Discretionary Review Full Analysis

Date: May 10, 2012
Case No.: 2011.1439DDD
Project Address: 2539 Vallejo Street
Permit Application: 2010.10.05.2357
Zoning: RH-1 (Residential House, One-Family)
40-X Height and Bulk District
Block/Lot: 0561/022
Project Sponsor: Vida and Craig Campbell
2539 Vallejo Street
San Francisco, CA 94115
Staff Contact: Aaron Starr – (415) 558-6362
aaron.starr@sfgov.org
Recommendation: **Take DR and Approve with Modifications**

Photo #1 - Front of house

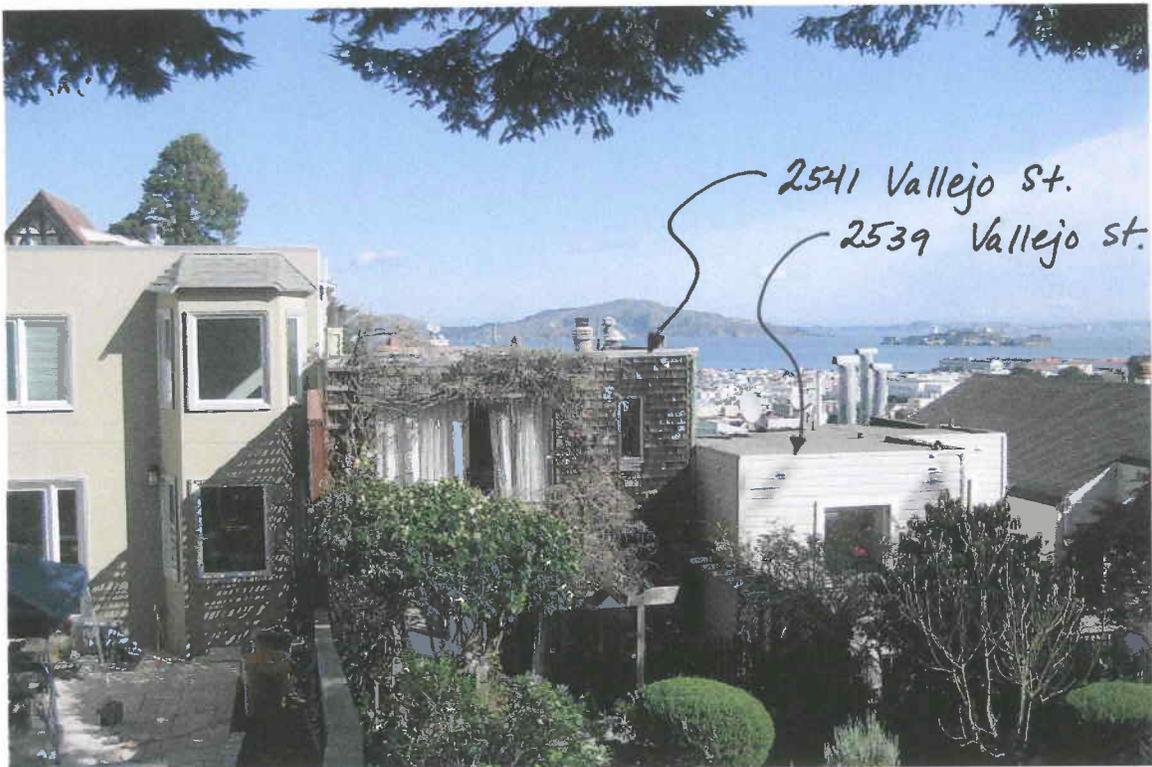
The first reason is that the house is too large for the intended lot. The three houses located at 2539, 2541 and 2543 Vallejo were built at the same time by a father for his two daughters, with similar proportions and equal back gardens. By adding a floor, extending into the back garden, as well as putting on a deck and patio, the building becomes disproportionate to its surroundings (**See photos #1,2**).

2 WEST ELEVATION
 A4.01 1/8" = 1'-0"

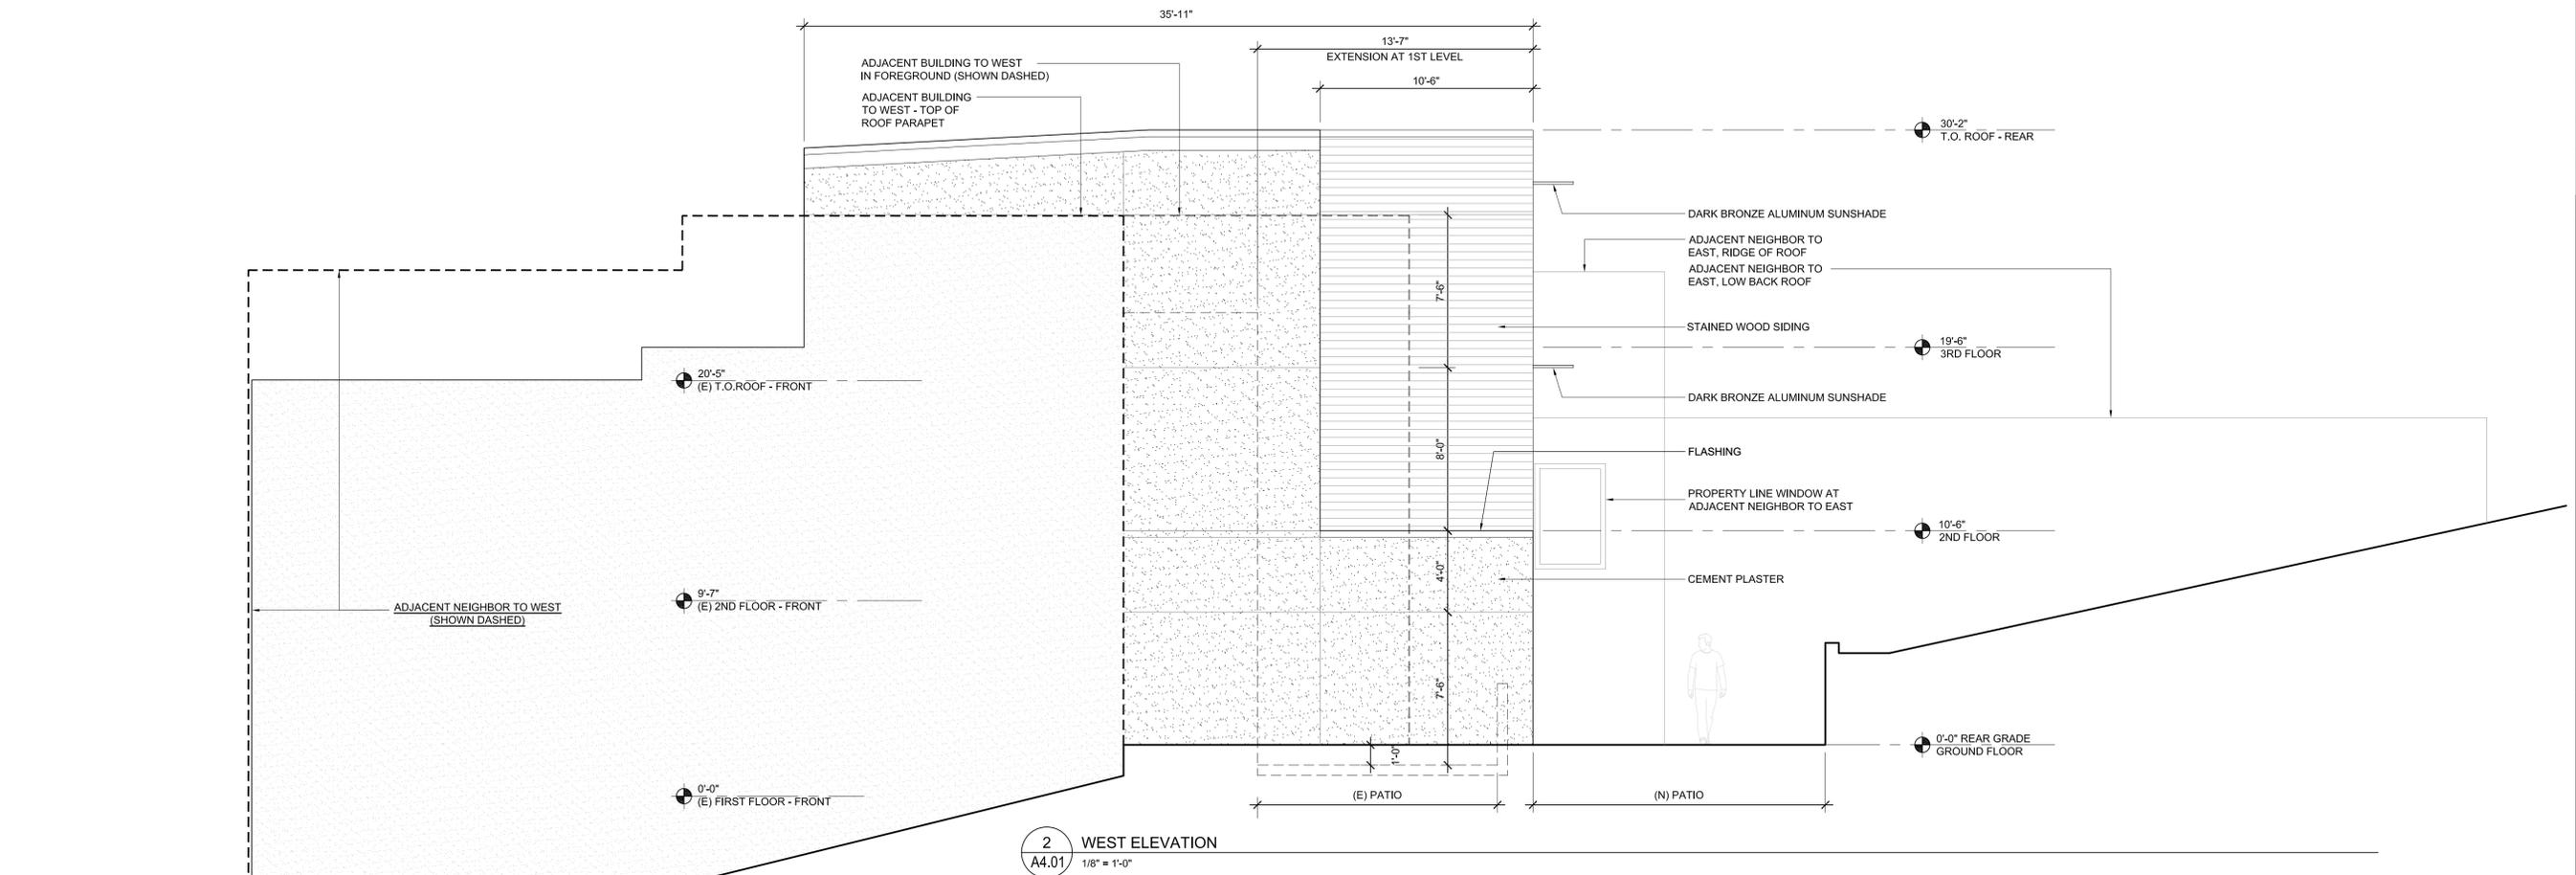
Comments: The Department determined that the originally proposed project would negatively affect the adjacent neighbor to the west because it will create a 3-story blank wall that extends approximately 20.5' feet from the closest rear wall of the adjacent western neighbor. In situations like this the RDGs as well as the Cow Hollow Design Guidelines prescribe setbacks to address negative affects to light and to reduce the negative visual impact that such situations create. The project sponsor has revised the proposal so that there is a 3' setback at the western side of the property; however the Department does

not find that this is sufficient and is still requiring a 5' setback for the last 10.5' of the building. The revised project now matches the eastern neighbors light well.

Comments: The Department finds that the height and depth of the proposed rear addition would be appropriate if a 5' deep by 10.5' long setback was provided to address negative effects to the western adjacent neighbor.
